PREPARED FOR SITE PLAN CONTROL APPLICATION - RESPONSE #01

3 SELKIRK ST.

DESIGN BRIEF

JULY 14, 2026

DESIGN PROGRESSION
Building Evolution

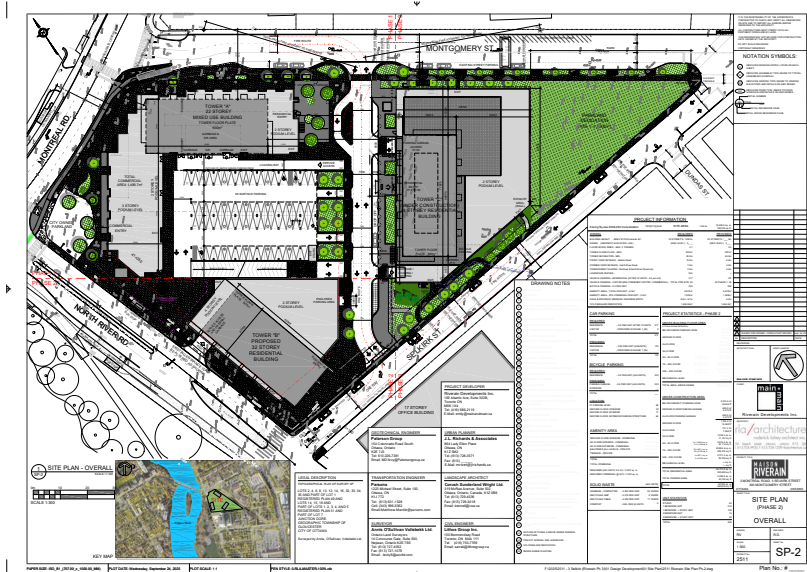
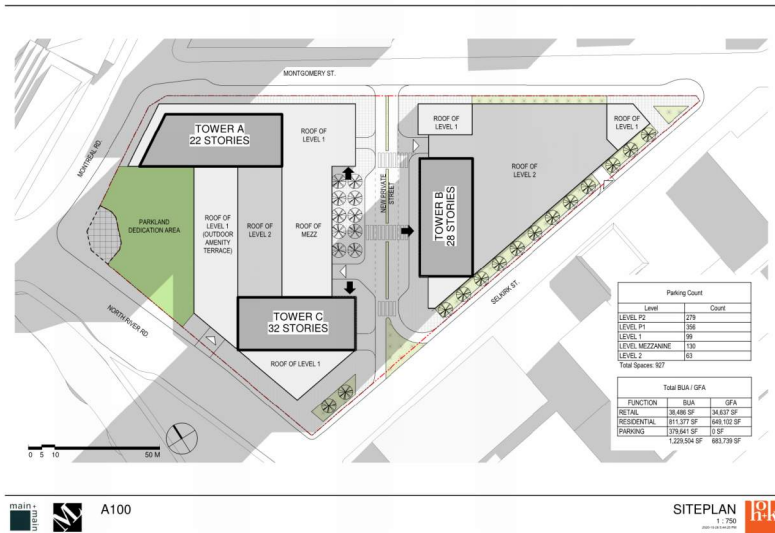
18	Wind and Shadow studies are also required in order to review the impacts of the proposed development on the subject and surrounding lands.	Noted.
23a	Podium heights – why have you not matched rest of development? Consider maintaining similar heights.	The increased podium height was a request from a previous UDRP and creates visual interest in the site and improves the building density and efficiency to make the project financially viable.
